5 August 2021

C92266v2

Letter of Addendum (refer to AIA Xavier C92266) – Design proposal/methodology Barkers Road Intersection/Southern entrance – Xavier College.

Figure 1. Tree location, Tree 189-195. (ArborPlan, Aug. 2021).

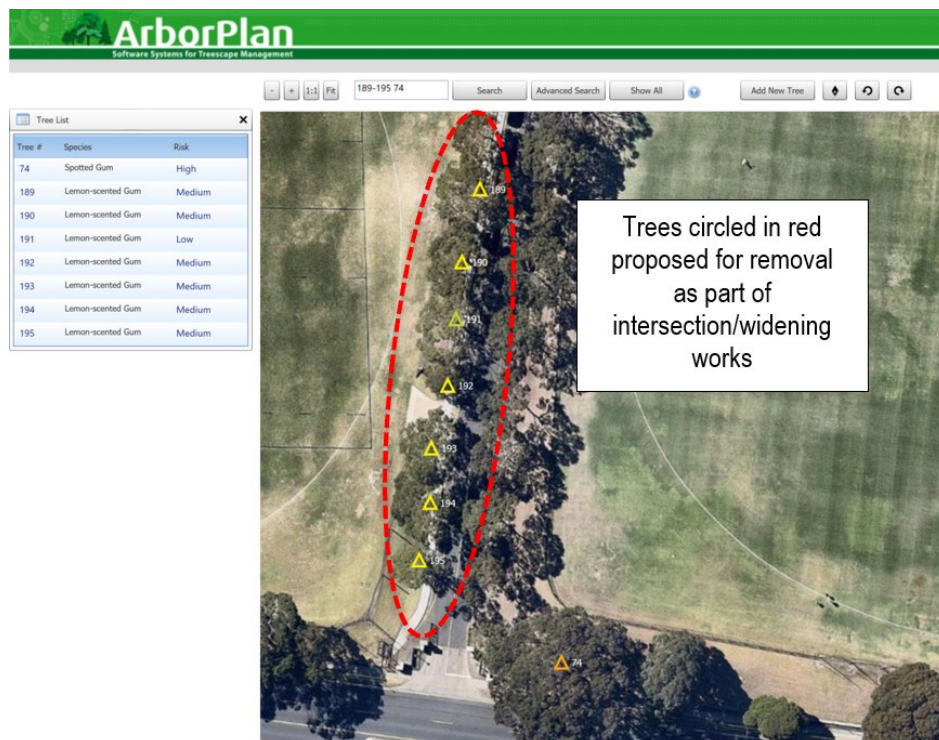
Proposed Tree Removals – Trees 189-195

Figure 2. Excerpt from southern entry/intersection plan – DP0104 TP3. (Client, July. 2021).

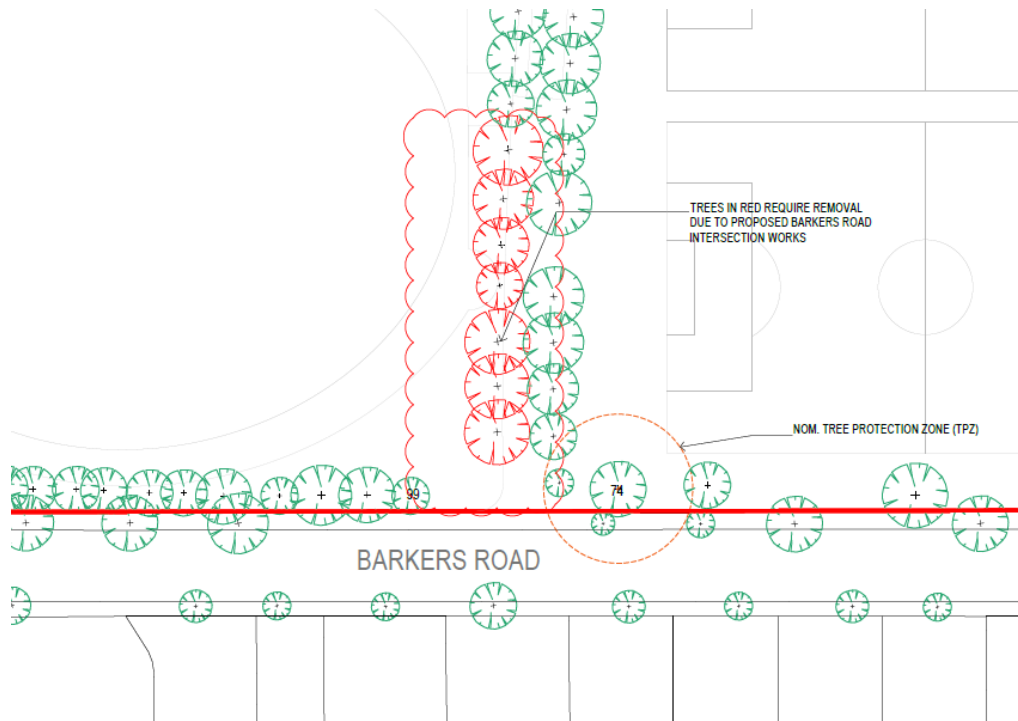
In order to facilitate the retention of Tree 74 (see Figure 3), proposed intersection/widening works (Barkers Road) have been reconfigured (shifted west). These works shall require the removal of seven (7) trees as per Figure 2 below (circled in red);

Where proposed excavation works (as per supplied plan(s) – TPZ Plan Southern Entry – DP0104 DP3 – July 2021) are located within the documented TPZs of Trees 189–195, and as such represent a major TPZ encroachment (refer to AIA), the proposed encroachment shall not be considered acceptable.

- Trees 189–195 are recommended for removal in advance of works, to be replaced as per the provisions of Section 7 'Offset Tree Planting' (Arboricultural Impact Assessment – C92266, July 2021).

Figure 4. Excerpt from Barkers Road Intersection plan – TPZ001 P1. (Client, August 2021).

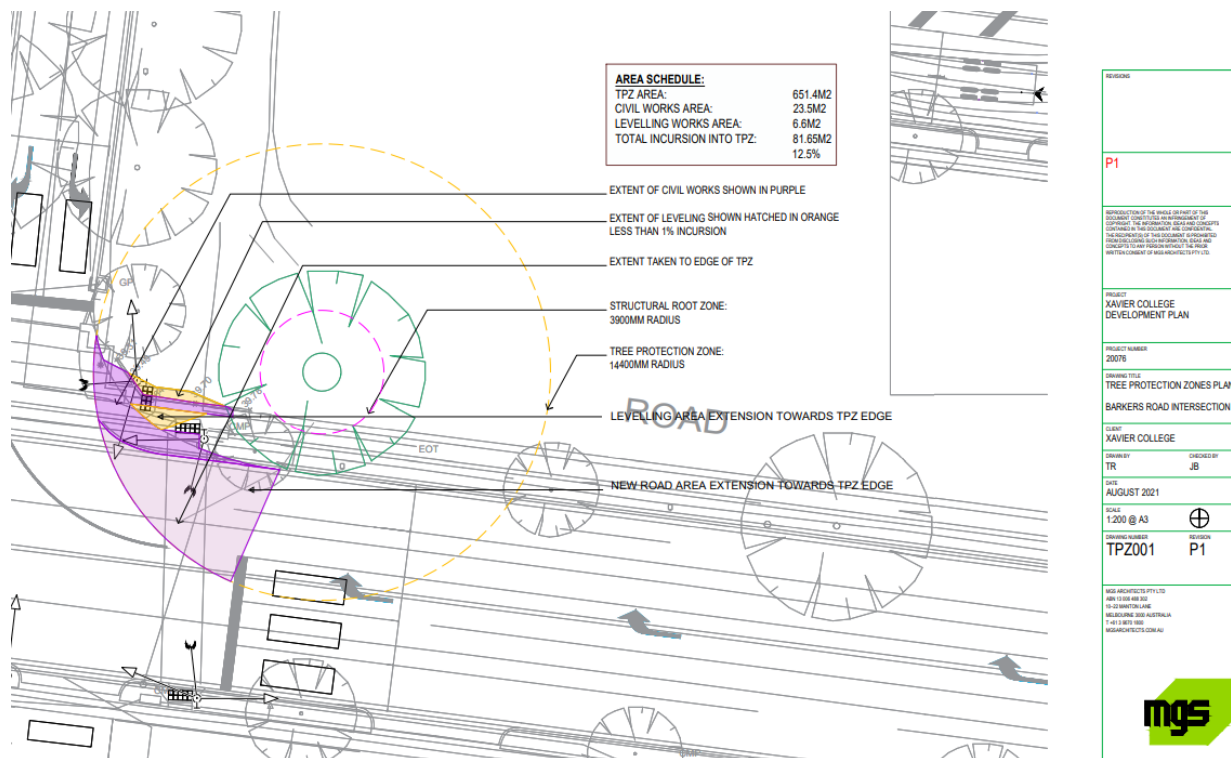
Figure 4 is an excerpt from the TPZ plan (Barkers Road Intersection – TPZ001 P1) which shows the extent of civil works (including leveling and retaining components) and total incursion calculations.

In keeping with root sensitive design, proposed intersection widening works have previously been shifted west of the existing entrance way (off Barkers Road) to minimise the potential impact(s) on Tree 74.

Design calculations indicate a 12.5% TPZ encroachment, which is deemed 'major' (i.e. >10%) by the Australian Standard AS 4970–2009: *Protection of Trees on Development Sites*. Incursions of this type and proportion may be considered tolerable with the implementation of additional controls.

Where proposed excavation works (as per supplied plan(s) - Barkers Road Intersection – TPZ001 P1 – August 2021) are located within the documented TPZ of Tree 74, and as such represent a TPZ encroachment (refer to AIA), the proposed encroachment shall be considered acceptable where:

- Other relevant generic tree protection measures (as listed in AIA) can be met, and;
- The TPZ for Tree 74 is extended in a contiguous manner in an opposite direction to works (i.e. to the north and east) by a minimum of 12.5%, and;

- Where all proposed excavations within the TPZ are undertaken in a root sensitive manner (e.g. manually dug and/or through the use of a hydrovac/air spade), and;

- Where excavations within the TPZ are undertaken under the direct supervision (or with the express consent) of the project arborist, with;
- A degree of root severance, where documented and considered tolerable, which may be undertaken by the project arborist.

- Where root mass deemed significant by the project arborist is encountered in the course of works, further reporting and remediation may be required.
- Plant health care measures (i.e. mulching and irrigation/drenching) are installed and implemented by a competent person(s) and documented by the project arborist post installation (but before project sign-off).
